Item Name: Replacement Skidtube, High Gear with Standard Wearplates Fits LH or RH

DRAWING NO. D2650	TITLE 206/407 SKIDTUBE ASSEMBLIES	REV. F	DART AEROSPACE LTD ENGINEERING ORDER		D.E.O. NO. D2650-F-1	SHEET NO. SHEET 1 OF 1	SCALE NTS
DRAWN <i>[Signature]</i>	CHECKED A.P.	MFG. APPR. <i>[Signature]</i>	APPROVED <i>[Signature]</i>		DE APPR. <i>[Signature]</i>		
DATE 12.10.12	DATE 12.10.22	DATE 12.10.22	DATE 12.10.22		DATE 12.10.22

CHANGE C'BORED WELDED CROSSBOLT SPACERS TO SWAGED SPACERS

DETAIL G

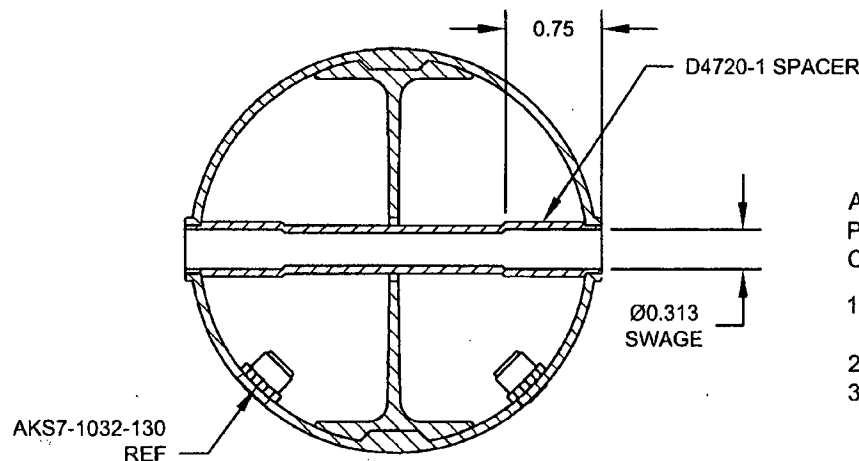
ADD DETAIL G BELOW, WHICH IS THE SAME SECTION VIEW AS DETAIL D OF DWG.

C'BORED HOLES ARE **NOW SWAGED** PER DETAIL G BELOW. FOR THE Ø0.375 HOLE THAT IS NOT C'BORED, WELD PER DETAIL D OF DWG (SEE AMENDED DETAIL B FOR REFERENCE).

FOR Ø0.375 HOLES ONLY

DETAIL B

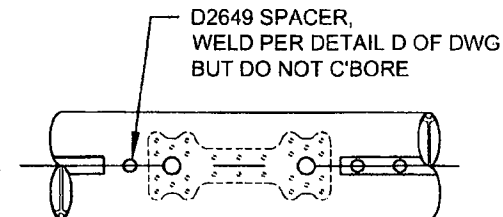
FOR HOLES THAT ARE CURRENTLY C'BORED ONLY
NOT TO SCALE

AMENDMENT TO DETAIL B
NOT TO SCALE
